# **Matanuska-Susitna Borough LiDAR & Imagery Project Quality Assurance Report Point Mackenzie Block (V2)**

**Written by Rick Guritz**

**Alaska Satellite Facility**

**February 11, 2013**

Figure 45, Seam in Bare-Earth DEM (Left) Corrected (Right).

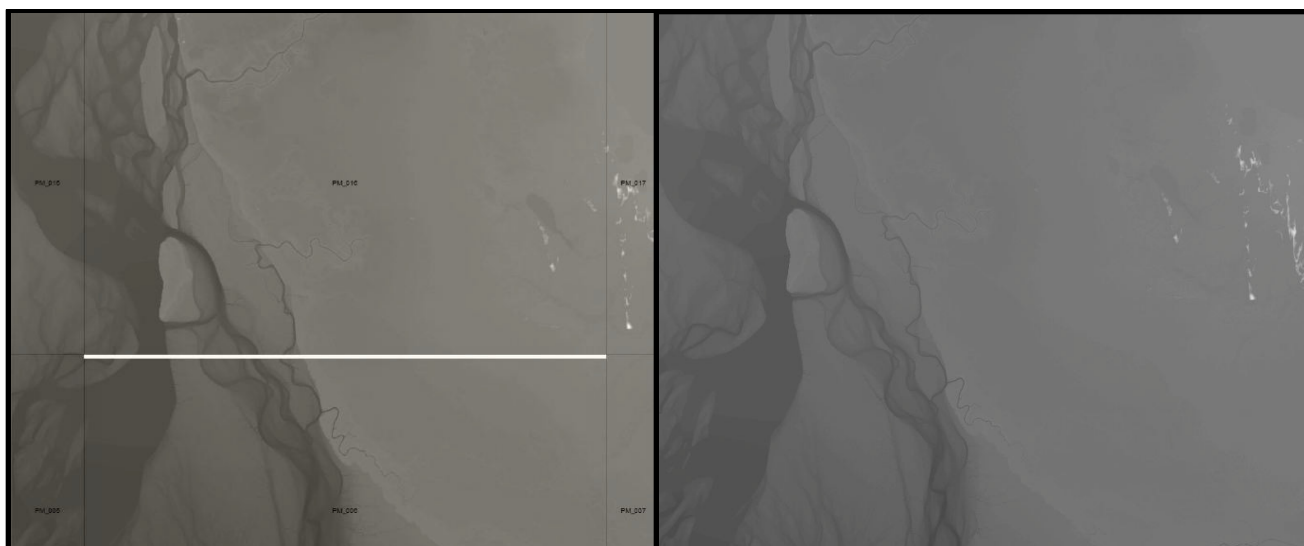
**Detected Seam in bare-Earth DEM** – On 11/09/2011, an observed seam was reported when trying to mosaic bare-Earth DEM tiles. This seam was several pixels wide running west to East between two sets of tiles (see Figure 45).

Figure 46, Single Hydro Breakline Inaccuracies.

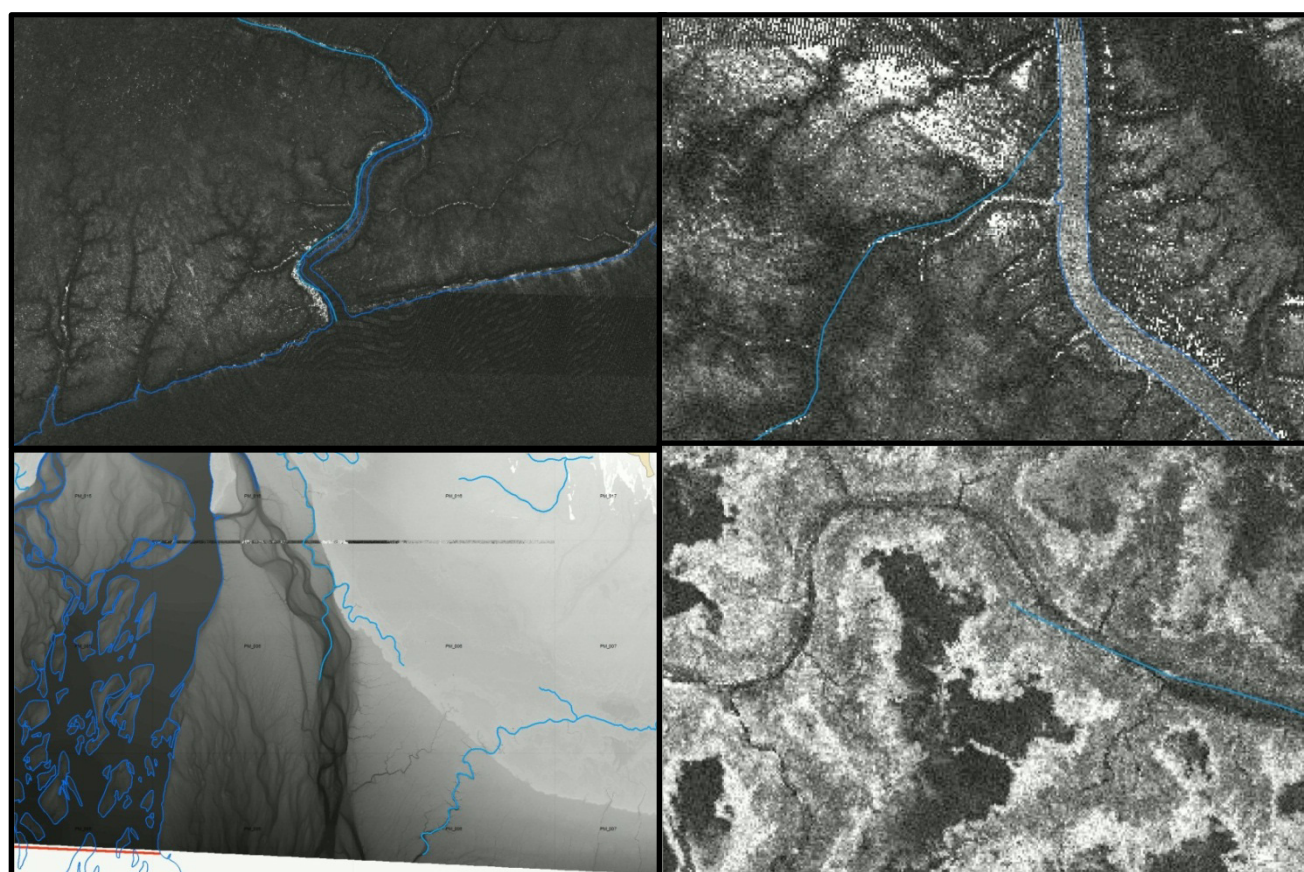
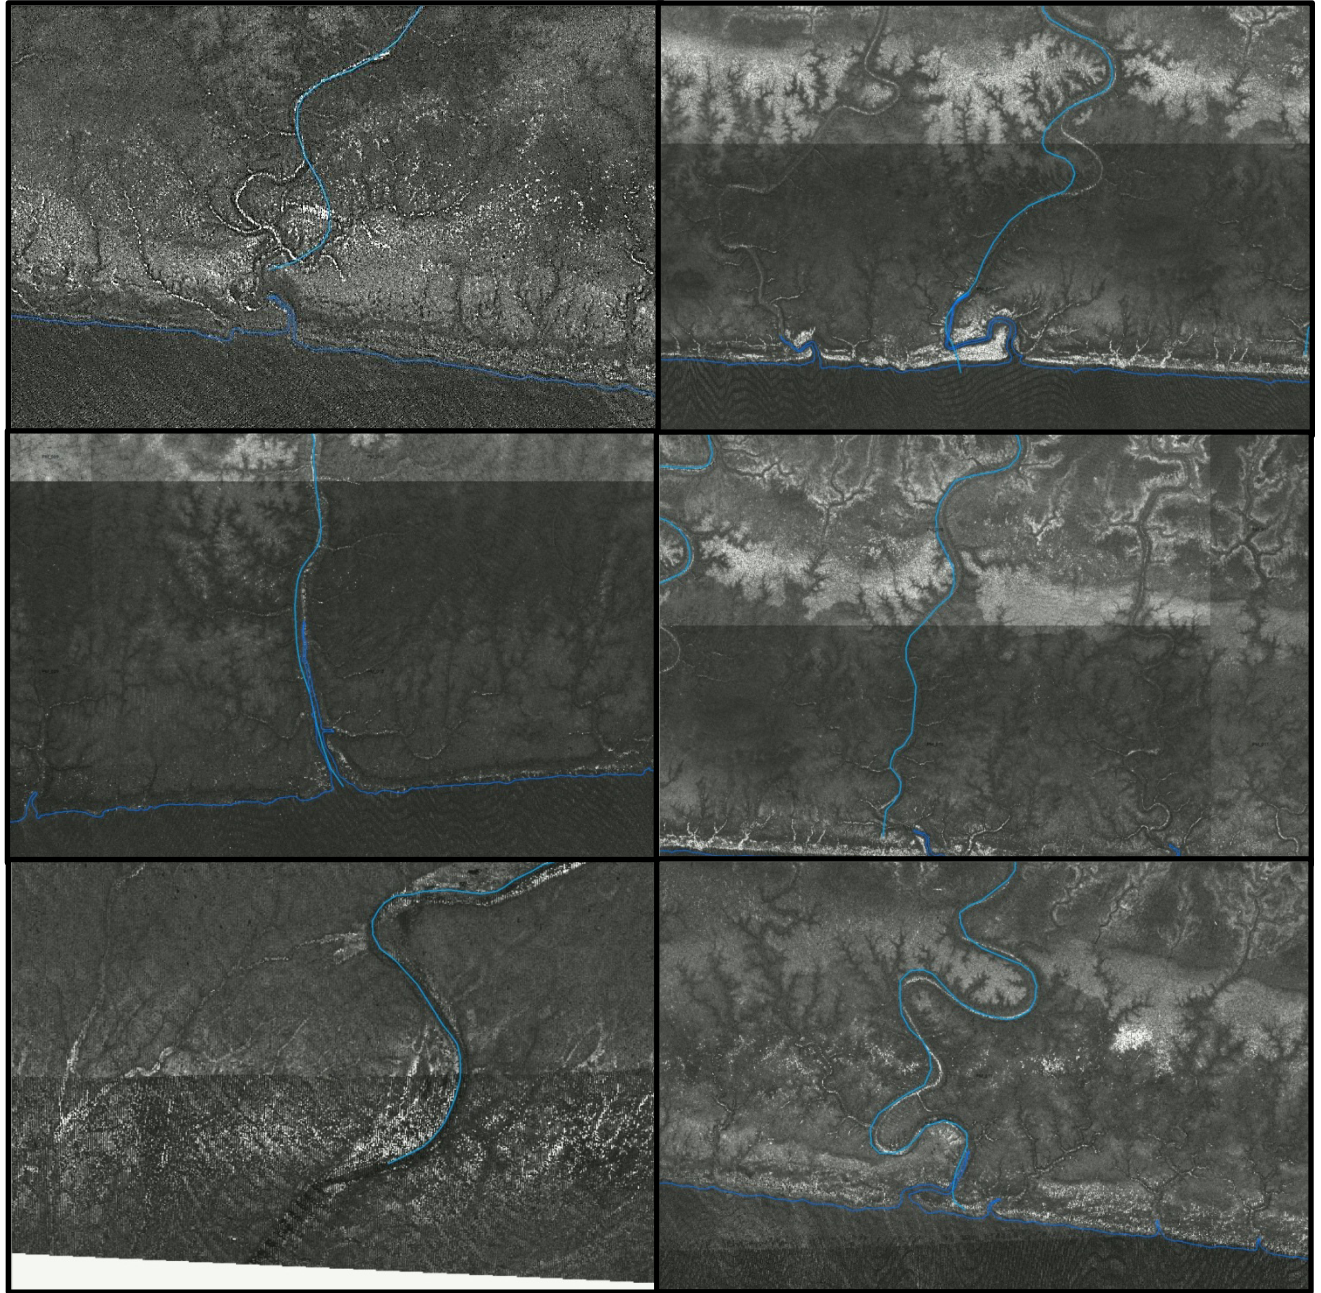
**Anomalies identified in single breaklines** – On 11/10/2011, ten screen captures were provided to Aerometric identifying inconsistencies between single breaklines and either LiDAR intensity data or the bare-Earth DEM (see Figure 46-47). These were primarily over channels in the mud flats. After review, Aerometric decided to remove most of these breaklines because they were too difficult to determine accurately. The corrected hydro layers have very few breaklines in the mud flats (see Figure 48).

Figure 49, Interpolation Artifacts in First-Return DSM (Left), Corrected (Right).

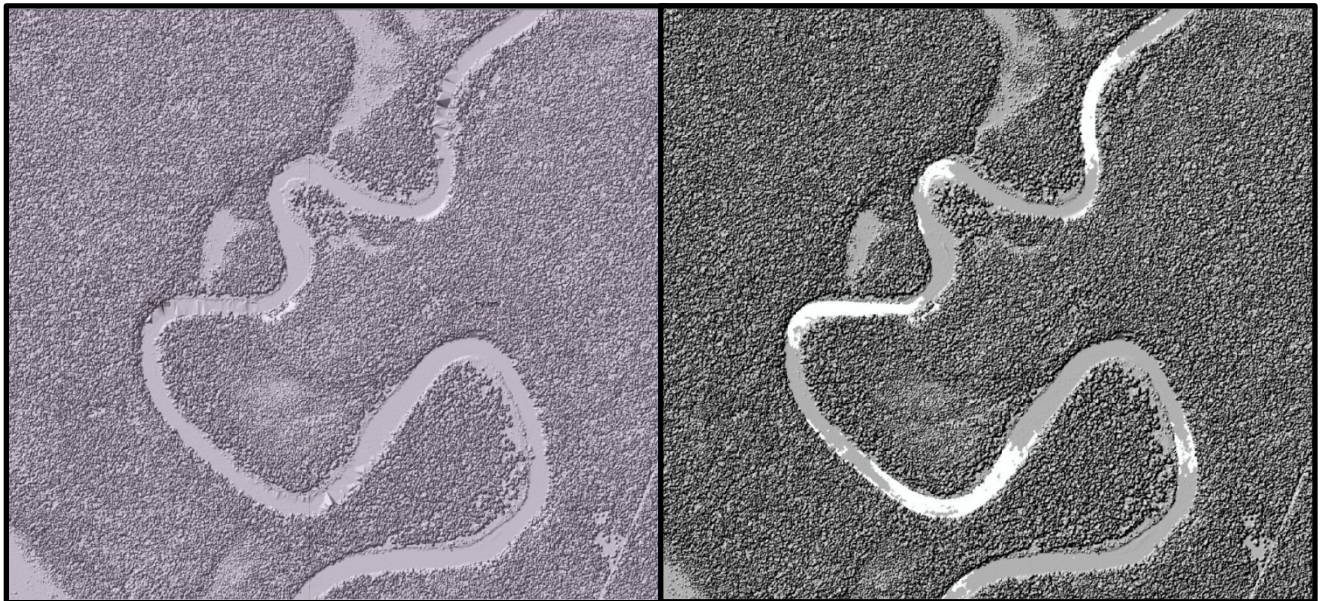
**Anomalies in First Return DSM** – On 11/11/2011, interpolation errors were observed in portions of the Little Susitna River (See Figure 49). In a true first return product, the LiDAR data should be evaluated on a cell by cell basis using the delivery grid as the basis for evaluation. All valid LiDAR returns (excluding points marked as withheld, class 1 and 7) should be evaluated for the highest return for that cell. For cells over water, there may not be a valid return for that cell, in which case the cell should be set to NoData. In discussion with Aerometric, they were using interpolation to fill holes over water which is undesirable. They were also using a gridding process that did not provide a true first return gridded product. After discussion, Aerometric was asked to change their processing methods to something that would provide a true first return product. This change was considered essential for a true canopy height product to be generated and for cross validation between gridded data and LiDAR point cloud data.

Figure 50, Seams in LiDAR intensity mosaic (Left), corrected (Right).

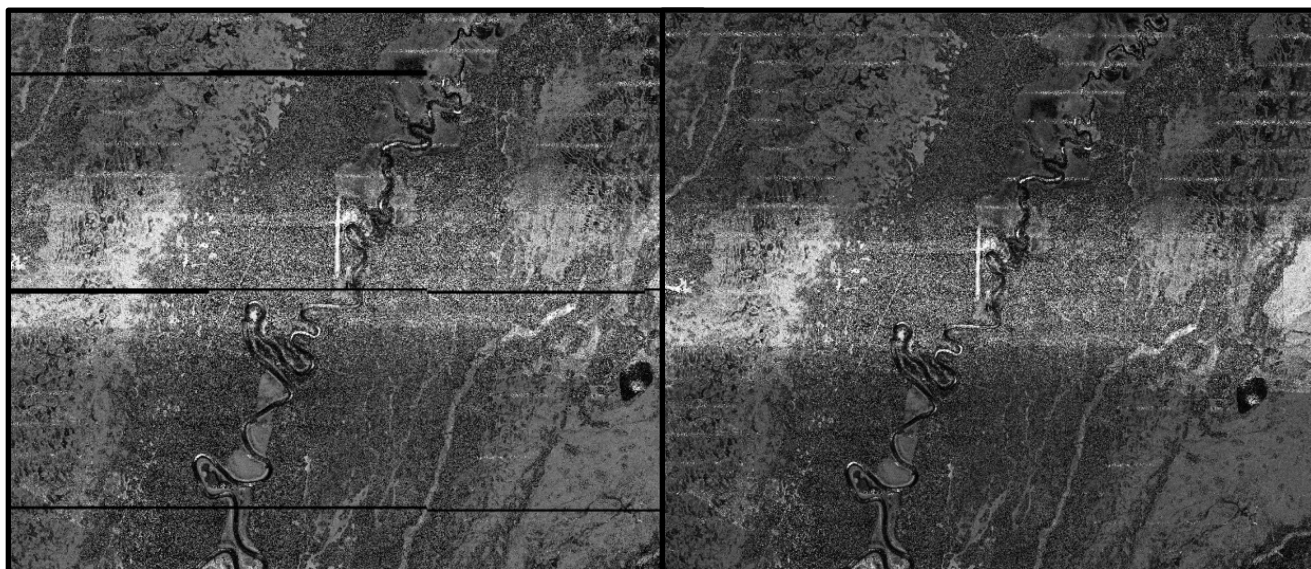
**Detected Seams in LiDAR Intensity data** – On 11/11/2011, observed seams were reported when trying to mosaic LiDAR Intensity data (see Figure 50). The seams were very obvious running from West to East and up to several pixels wide in places. After further investigation by Aerometric, they decided to use raster catalogs within the block geodatabase for all raster grids for future deliveries. This change eliminated the presence of seams in the data. It also was a much improved method for delivering raster data than what was initially used.

Figure 51, Coverage Gap (Port) in First Return (Left), Extended (Right).

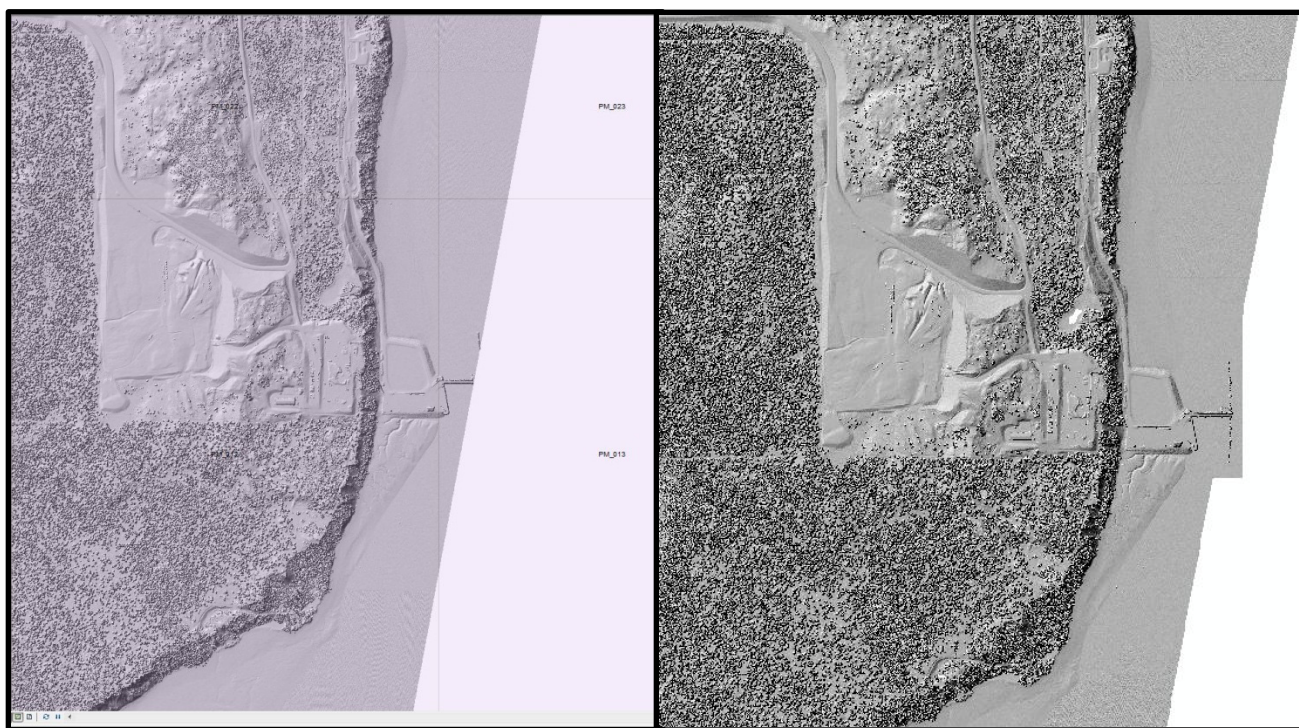
**Clipping of Point Mackenzie Dock** – On 11/11/2011, during visual assessment of the shaded relief product clipping of the Point Mackenzie dock was identified and reported (see Figure 51). An exception to the original block boundary was made to include the dock structure in both LiDAR intensity and first return DSM. This is an important structure that should be included in the resulting data. It should be noted that the original coverage requested by Matanuska-Susitna Borough GIS staff was the source of the error. Fortunately, the LiDAR coverage could be adjusted to cover the entire dock and breakwater.

Figure 52, Canopy Height – FR minus BE, Regions of negative values over -1.

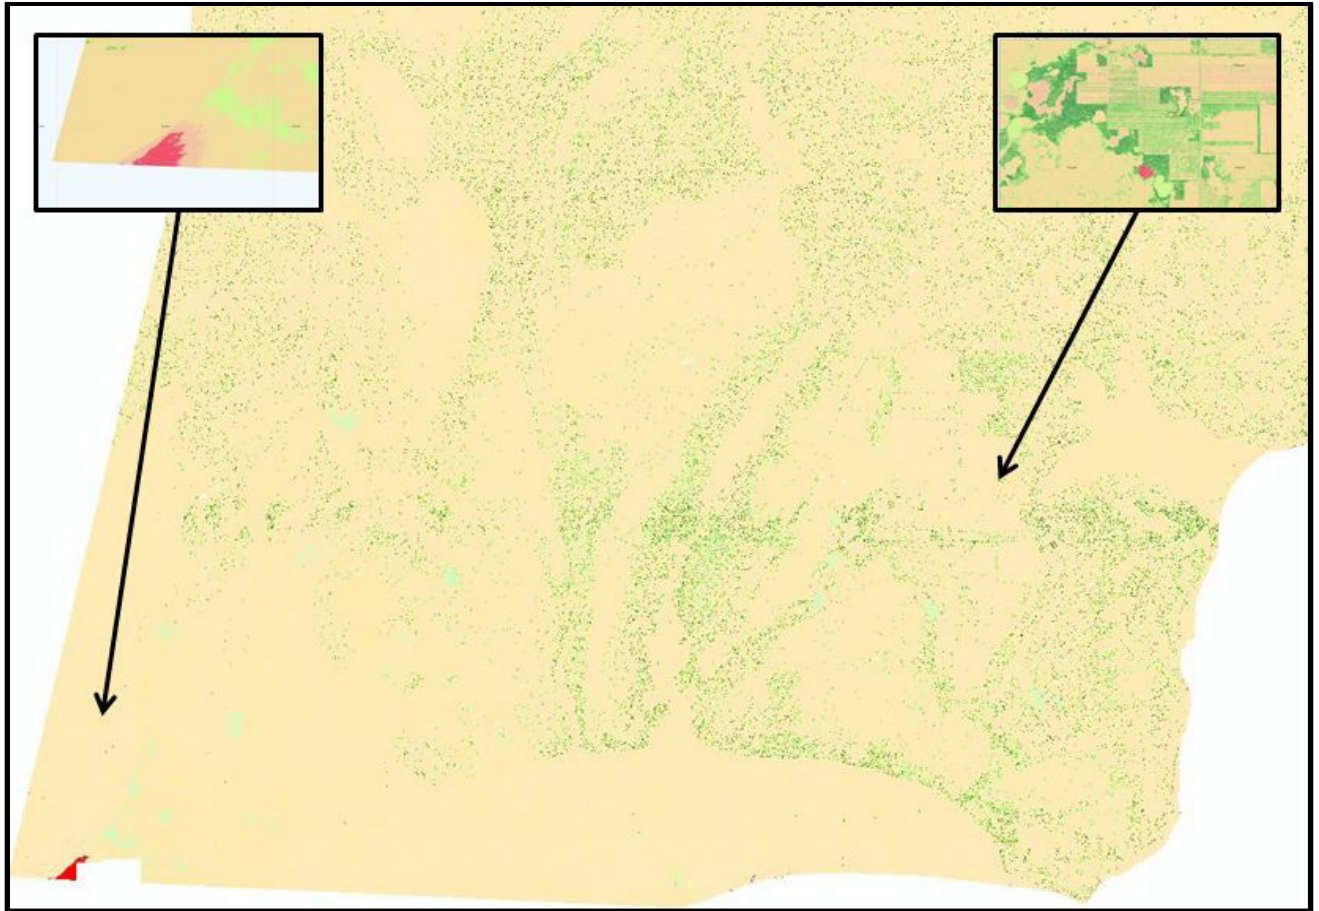
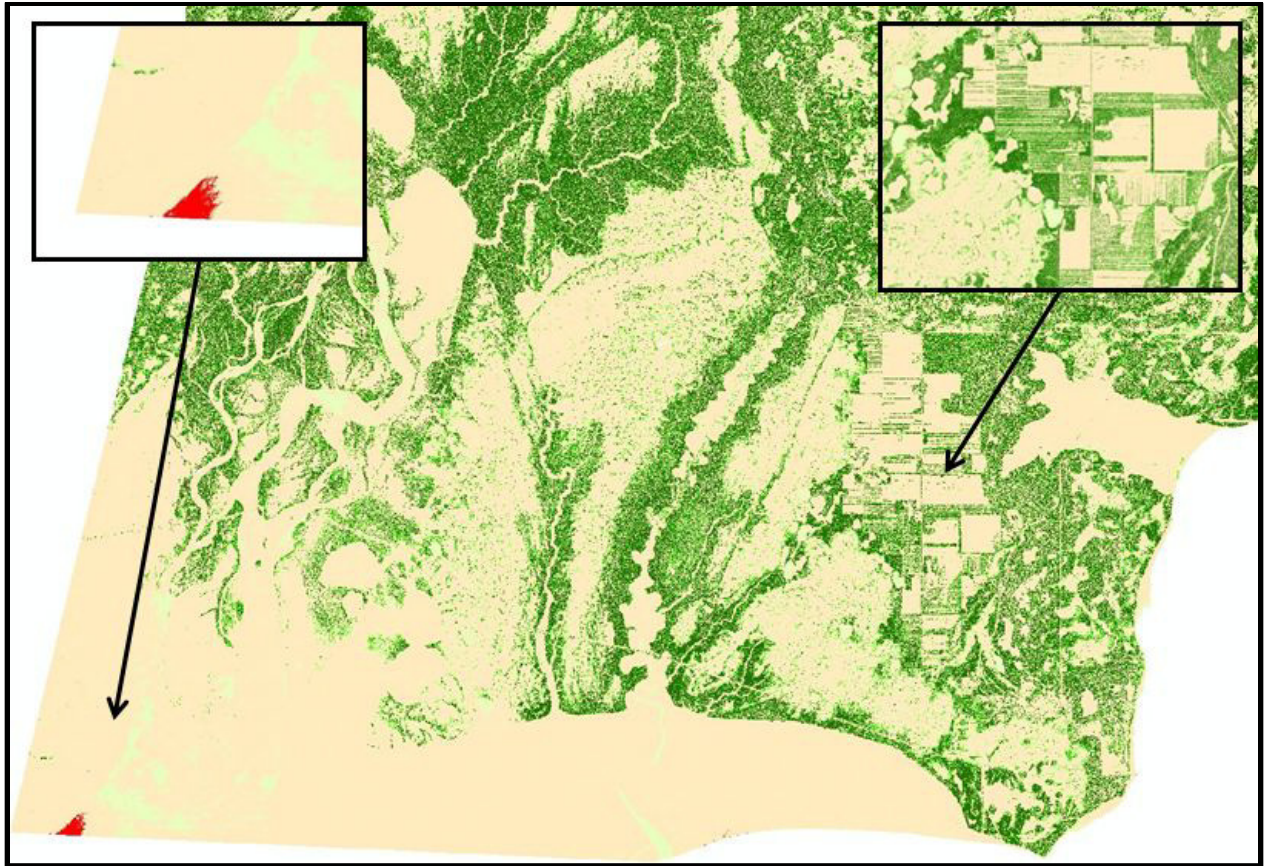
**Negative values in canopy height difference** – On 11/22/2011, negative values greater than -1 foot was observed in two locations of the Point Mackenzie block (see Figure 52). One was in the Susitna River delta, which was attributed to tidal fluctuations. The other was an area near some agricultural fields. One of these errors was eliminated when the rigorous first return DSM product was generated (See Figure 53). For our evaluation, we expect noise levels to be on the order of plus or minus one foot. Any negative values greater than one foot are not real and should be eliminated in the data.

Figure 54, Initial low vegetation class not as useful at 0-6 feet because it includes ground noise.

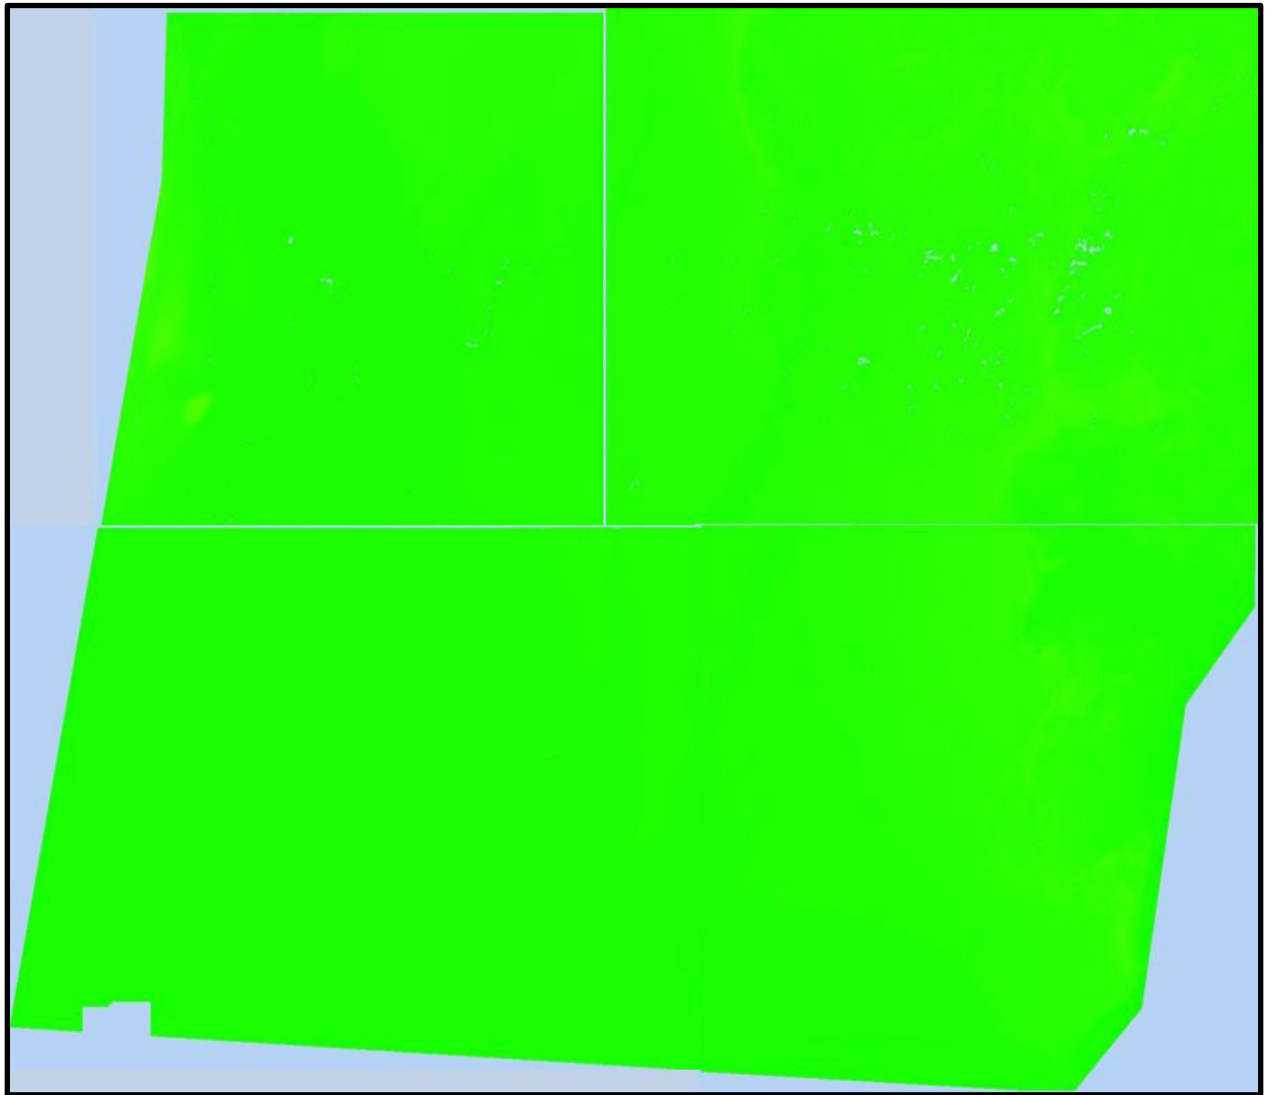
**Low Vegetation not useful as initially defined 0-6 feet** – On 11/23/2011, Aerometric was informed that the low vegetation class as initially defined with structures from 0-6 feet. There was no difference from the spatial extent of low vegetation and ground classes (See Figure 54). Given an accepted noise level in the data of one foot, UAF suggested that they redefine low vegetation as 1 to 6 feet. This should define a tighter spatial extent than ground and actually be useful, instead of redundant.
